**TOWN OF BLYTHEWOOD
BOARD OF ARCHITECTURAL REVIEW AGENDA
OCTOBER 21, 2019 – 6:00 PM
DOKO MANOR
100 ALVINA HAGOOD CIRCLE
BLYTHEWOOD, SOUTH CAROLINA**

B. 2019-06-COA – 221 Blythewood Road (TMS# 15100-05-33) Certificate of Appropriateness for construction of a Zaxby's restaurant (Robert Nutt) (TC) (AO)

To: Board of Architectural Review
From: Staff
Date: October 21, 2019
Applicant: Robert Nutt (MRP Design Group, Inc.)
Subject: Certificate of Appropriateness
TC (Town Center District) AO (Architectural Overlay District)
Location: 221 Blythewood Road
TMS# 15100-05-33

New
Windows

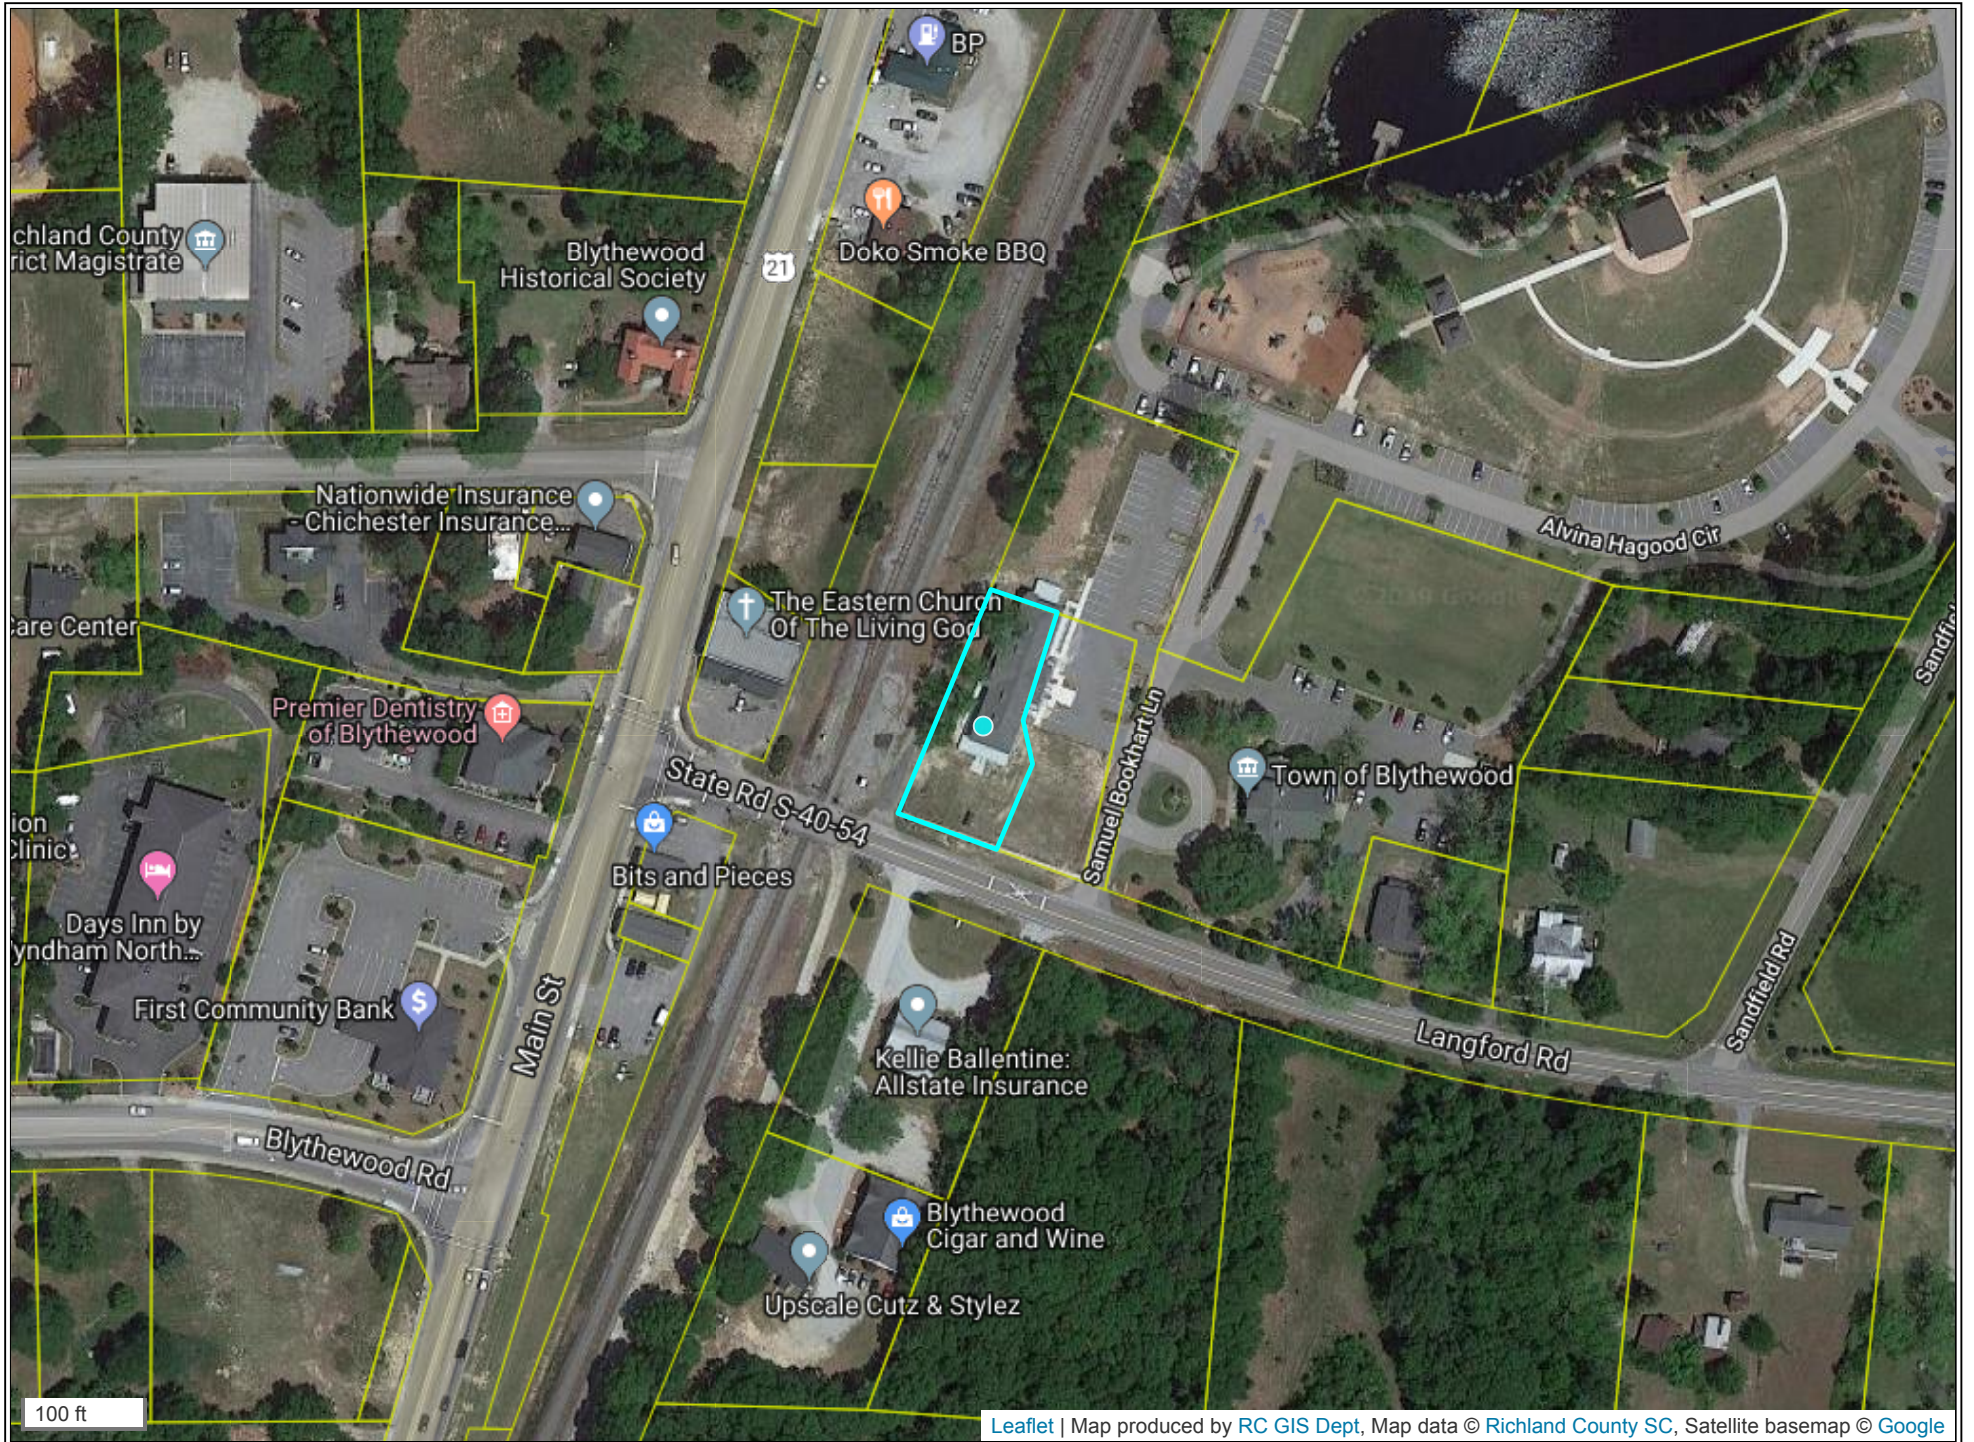
On 7-15-2019 the Board of Architectural Review granted COA approval for several alterations to the Blythewood Depot Building. The alterations previously approved by the BAR were the installation of two new windows on the rear of the building (side facing Main Street) and the addition/relocation of three doors to accommodate food deliveries and to direct means of access and egress for citizens. The doors/windows shall be identical to the existing doors/windows and the character of the property shall be maintained. The two new windows will be visible from Main Street.

Incorporation of traditional architectural elements is encouraged while recognizing that a multiplicity of architectural styles may be considered with regards to adjacent structures and proposed usage. The two new windows being proposed shall be identical to the existing windows in color, size, and materials. The proposed work will allow for additional natural light into classrooms.

The exterior modifications shall conform to the design and materials of the existing structure. All associated work will be completed and finished in a manner that is consistent with the Town Center District Zoning Design Guidelines (§155.182).
